ARCHITECTURAL DESIGN STATEMENT ADDENDUM

Prepared in response to DPHI request for further information dated 16 February 2026.

16-24 LORD STREET & ROSEVILLE 21-27 ROSEVILLE AVENUE

MARCH 2026

BUILDING C, GROUND FLOOR PLAN - SUBSTATION RELOCATION

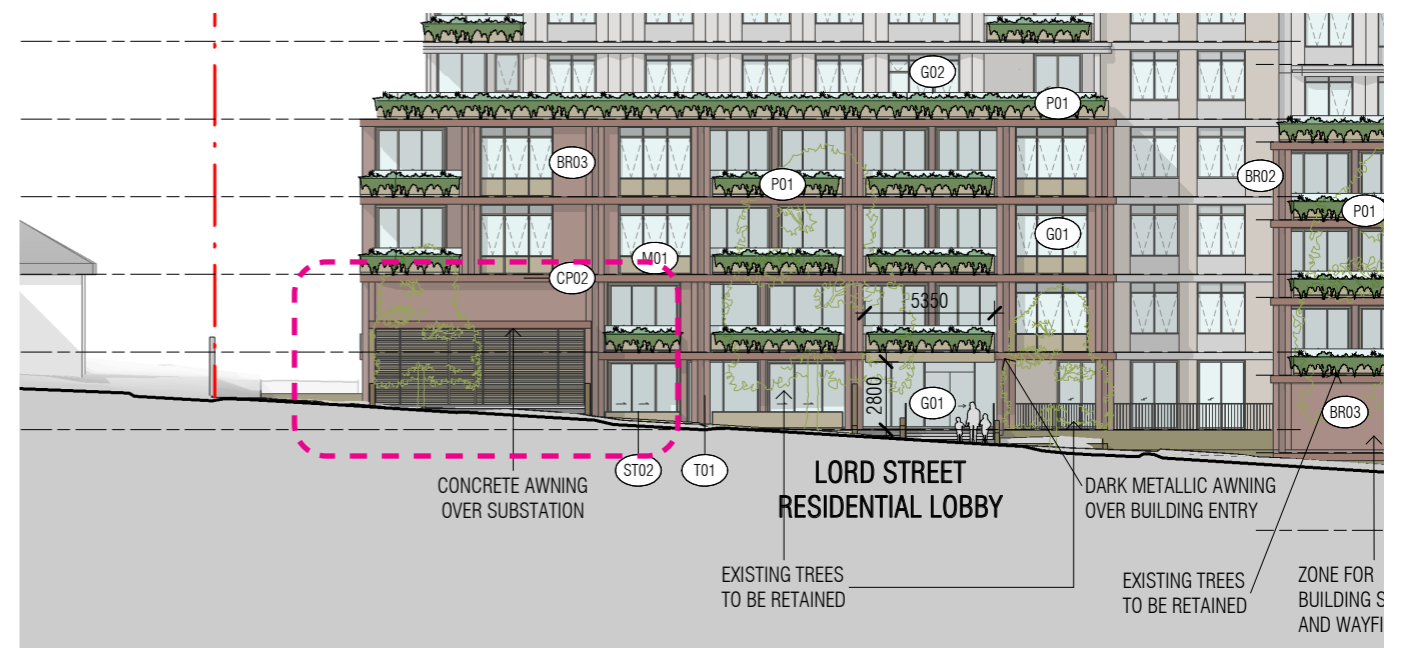
RELOCATION OF SUBSTATION TO SOUTH WEST CORNER OF BUILDING C

To eliminate the need for excavation, and thus allowing for the retention of Tree T20 (Street tree), the substation has been relocated from its previous location immediately to the west of the proposed driveway to the south west corner of the building.

The substation has been carefully integrated into the design of the development. Importantly, all streets trees to the Lord Street frontage may now be retained.

BUILDING A, SECTION F - RTS SCHEME

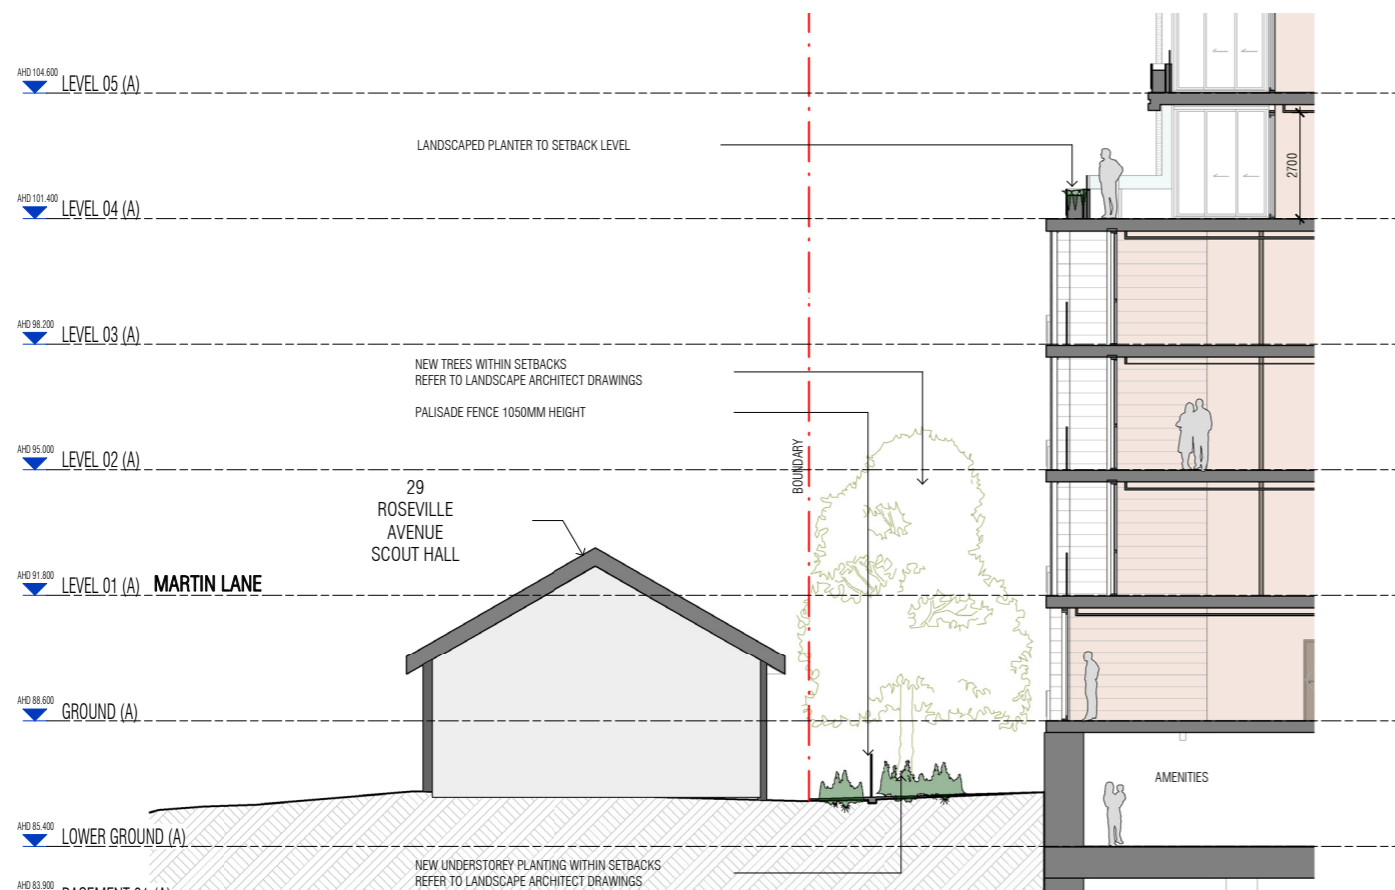
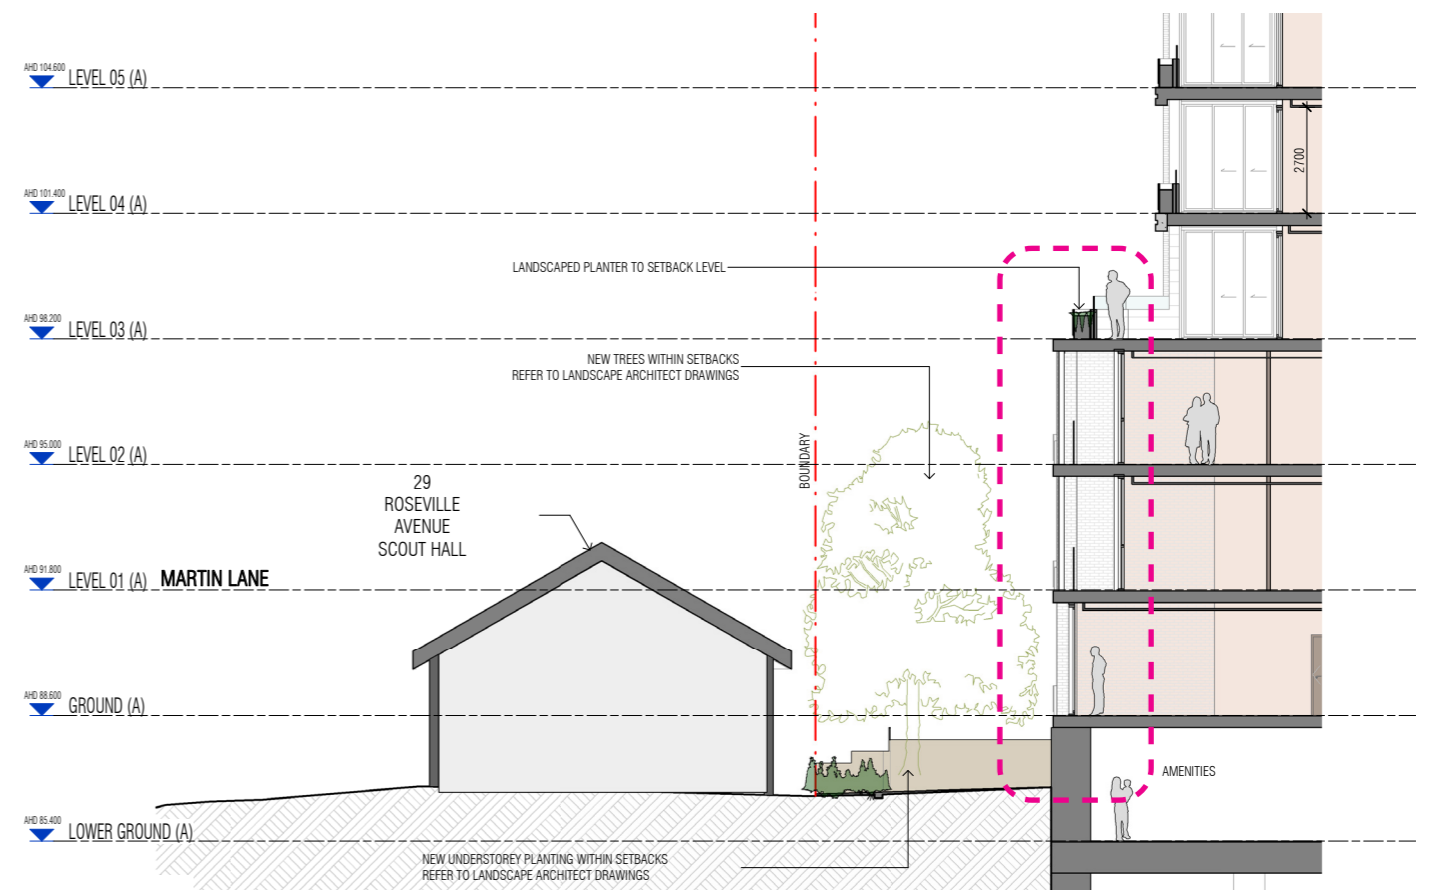
The podium height of Building A has been reduced from 4 storeys to 3 storeys to reduce the bulk and scale adjacent to the heritage listed scout hall.

BUILDING D, SECTION G - RTS SCHEME

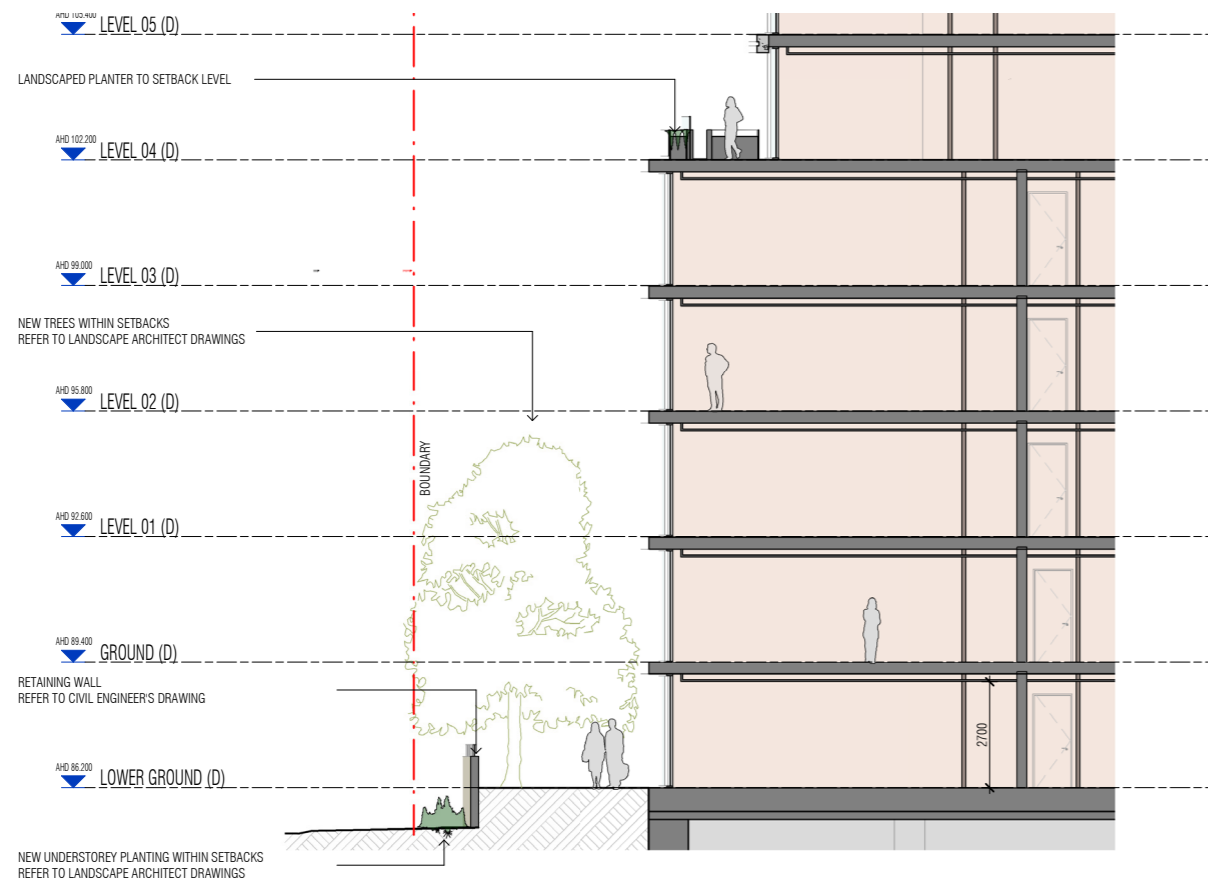
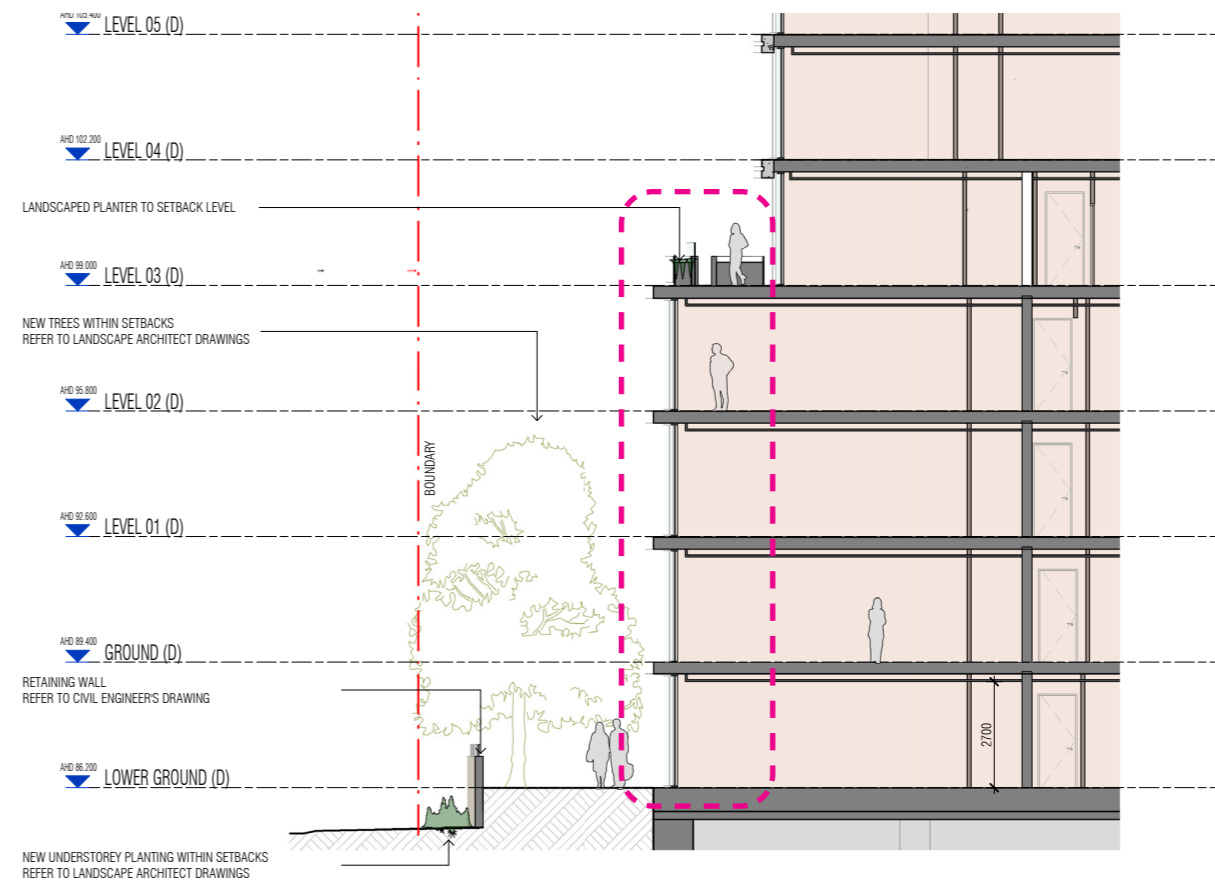
The podium height of Building D has been reduced from 5 to 4 storeys.

EAST ELEVATION - MARTIN LANE

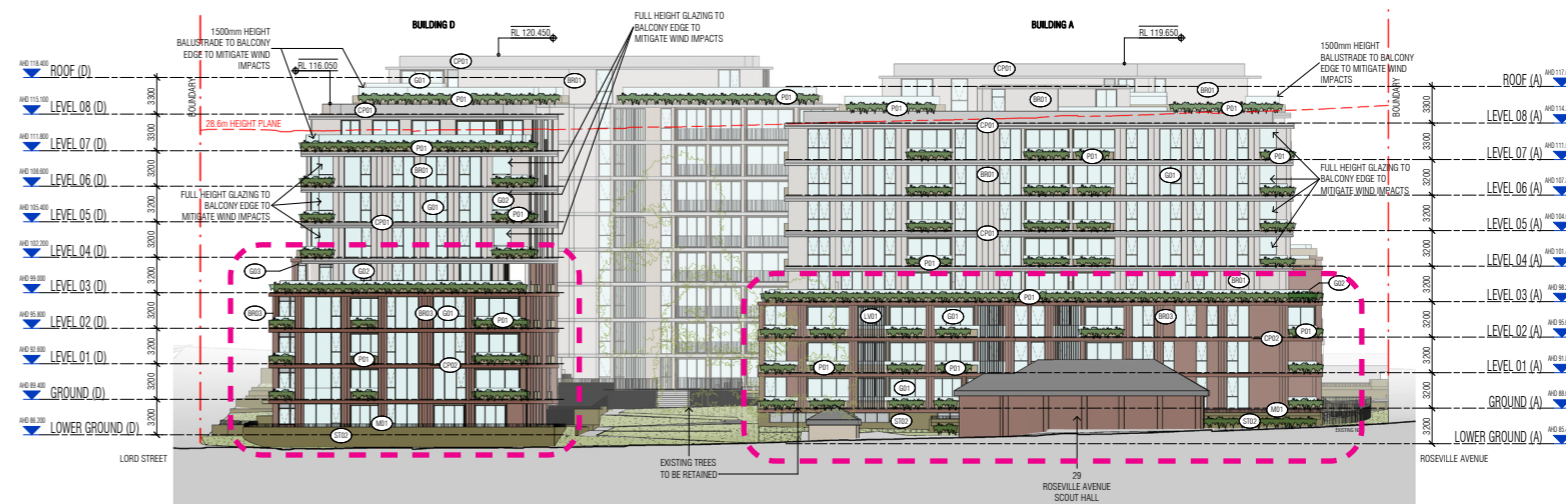
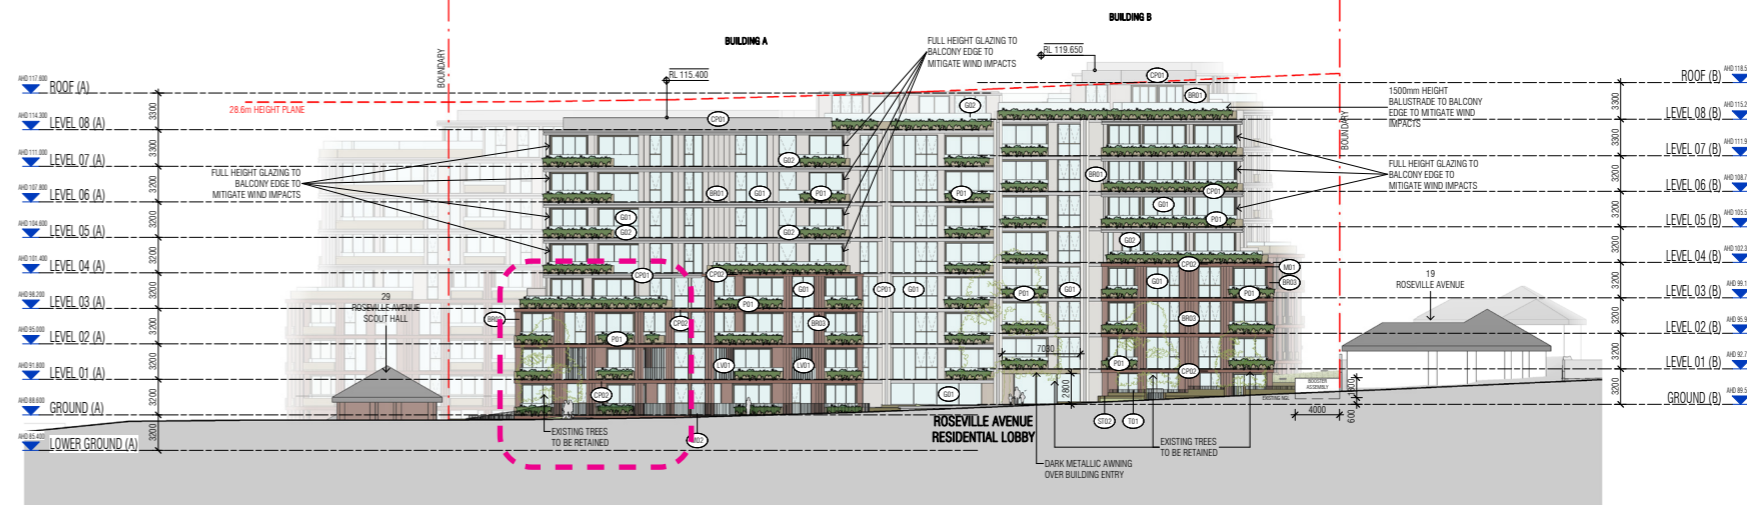
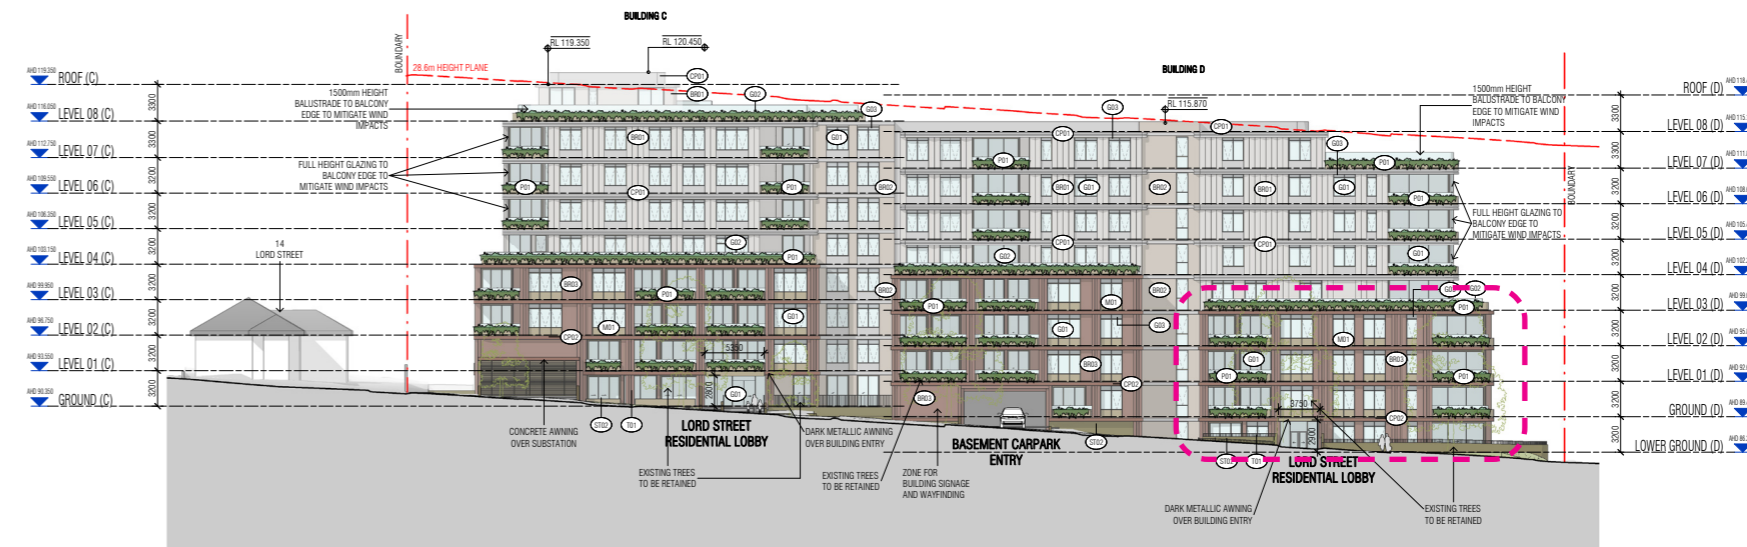
1.1 The proposed heights of the podiums should reflect the existing topography and provide a transition in scale to the adjoining context, particularly the Scout Hall. The Department recommends that you reduce and step the podium heights of Building A and D to further improve the relationship with the streetscape.

The design has been refined to allow for a further reduction in the eastern portion of Building A from 4 to 3 storeys to create a stepped podium form that follows the sloping topography of Roseville Avenue while reducing the visual bulk of the building when viewed adjacent to the lower scale Scout Hall building adjacent.

The eastern end of Building D has similarly been reduced from 5 to 4 storeys to accentuate the stepped form of the Lord Street elevation.

EAST ELEVATION (MARTIN LANE) - RTS SCHEME

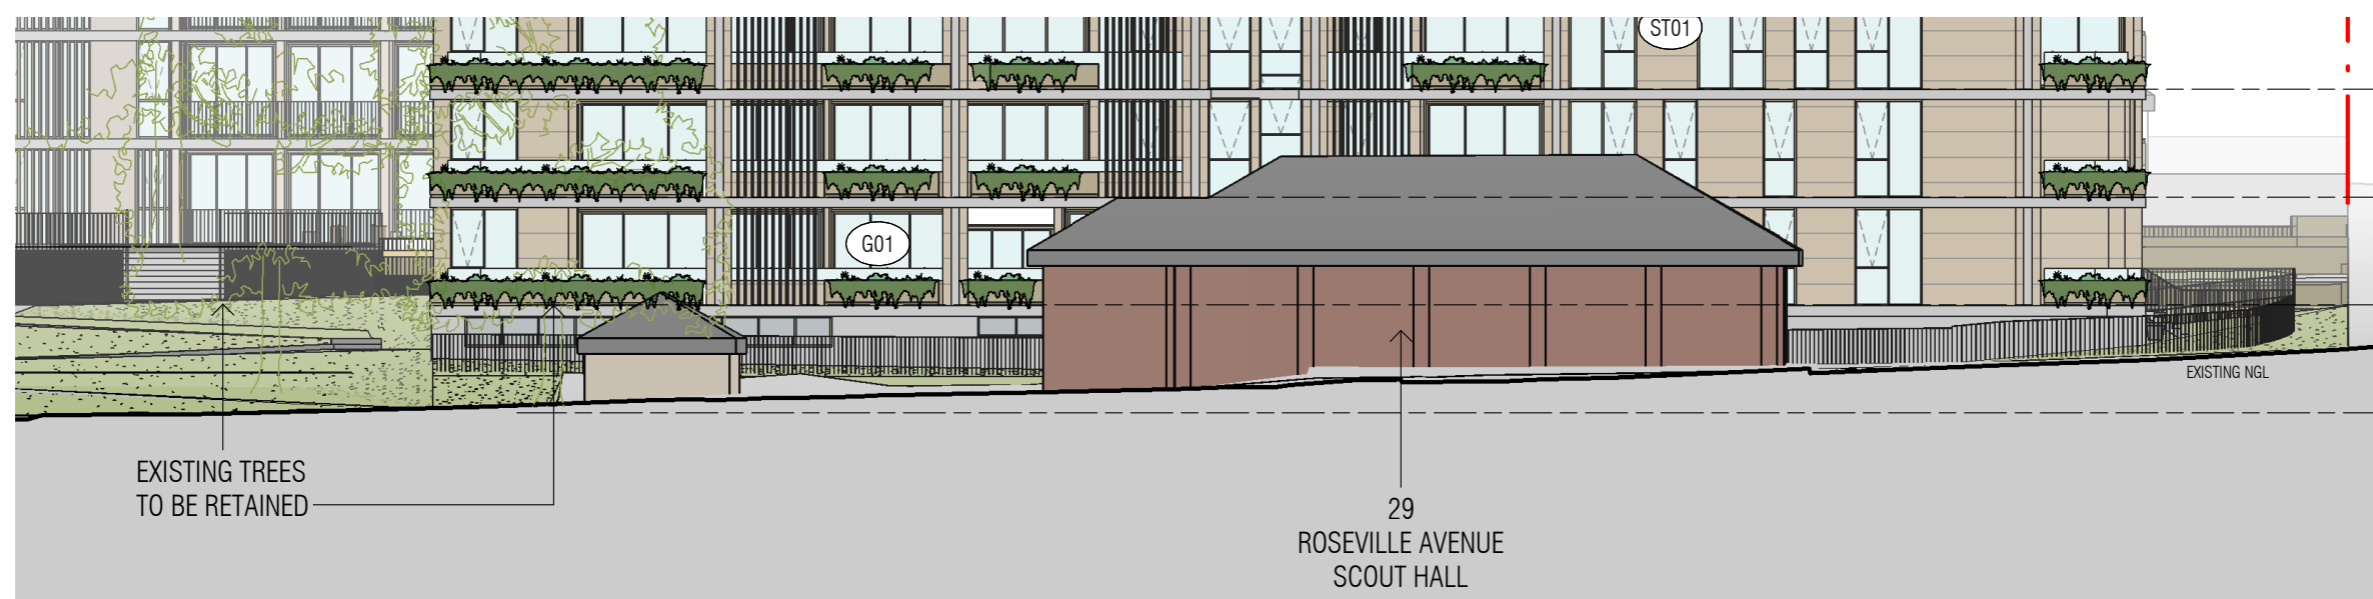
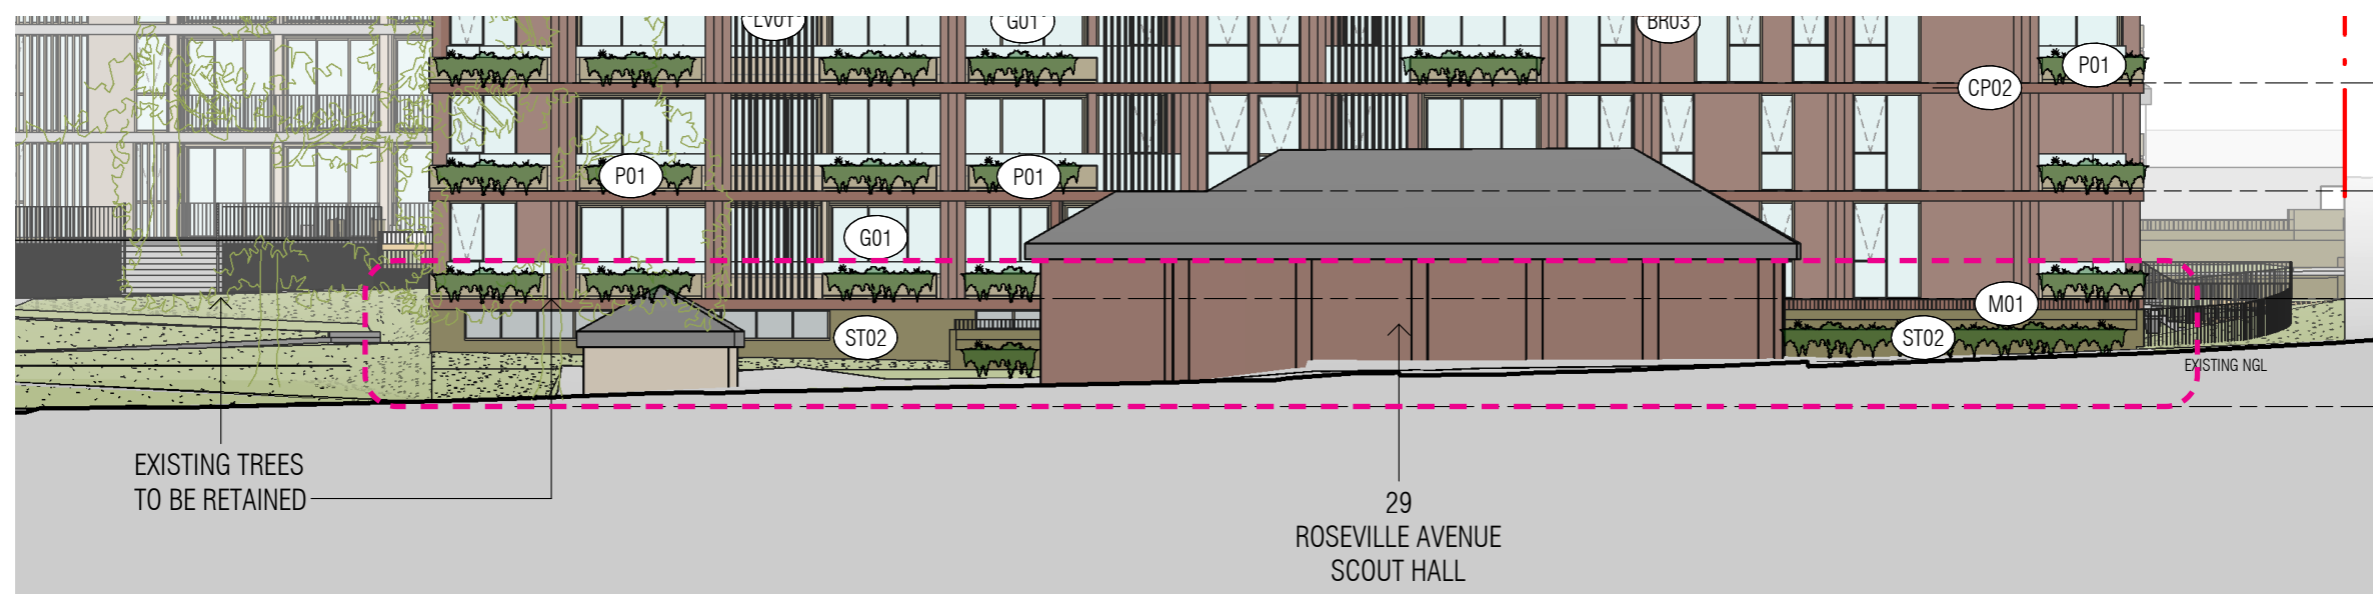
1.2 Consider further reducing the visual impact of the basement wall structures interacting with the Martin Lane public domain and the Scout Hall along the eastern boundary of the site by reducing height or changing its colour or materiality.

Clarification of the material selection for the basement wall fronting Martin Lane has been added to the architectural plans. This area was always intended to be treated with the same materials as the building section immediately above. To confirm the basement wall will comprise ST02 Medium Dry Stack Stone.
